All Vehicles Equipped with M139: CEL for P012800 - The coolant temperature is below the coolant thermostat specified temperature.

Topic number	LI20.10-P-076206
Version	23
Function group	20.10 - Coolant pump, coolant thermostat
Date	4/30/25
Validity	All vehicles with any version of M139 engine
Reason for change	remedy update

Attachments	
File	Description
Debris Aft of Sealing Surface of Thermostat.png

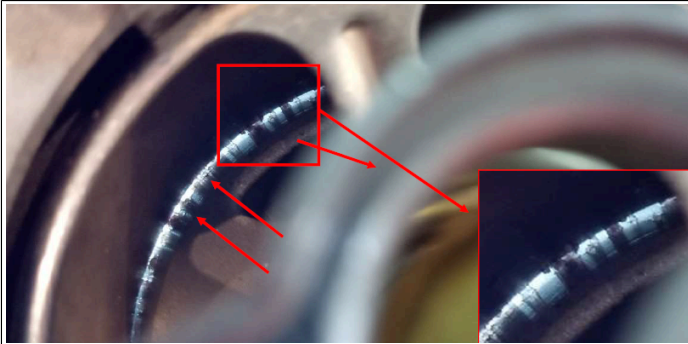
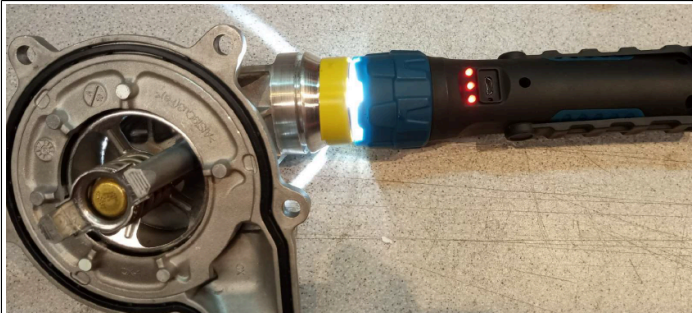
Debris in the coolant system

An updated thermostat will be installed. It must be requested through a TIPS case.

New screws must also be installed with the revised thermostat, PN N000000006341 (qty 5) will be used in place of the existing M8 screws.

The new screws must be torqued to 8 Nm.
